# Access Compliance Report

## Public Rights-of-Way

### (Curb Ramps)

Intersection ID: 2490	Main Street: BENTGRASS_RUN_DR	Cross Street: LYLETON_LN	Location: E
ADA ID: 4CDBF23A7BBC	Ramp Type: PerpDiag	Initial Pass/Fail: Pass	Overall Compliance: No
		Severity Score: 15

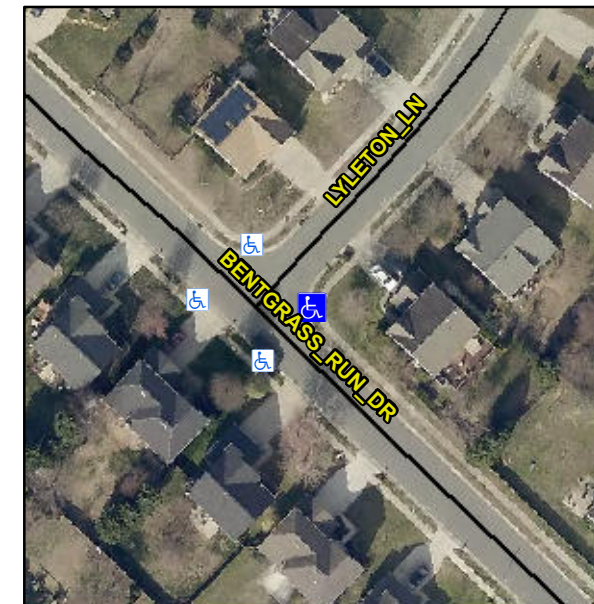
**Not Found, R304.2.1, R304.2.2-Perp, R304.3.2-Para, R305, R304.5.4**

**Remove & Replace Curb Ramp With Two New Directional Ramps or Equivalent. Remove & Replace Gutter.**
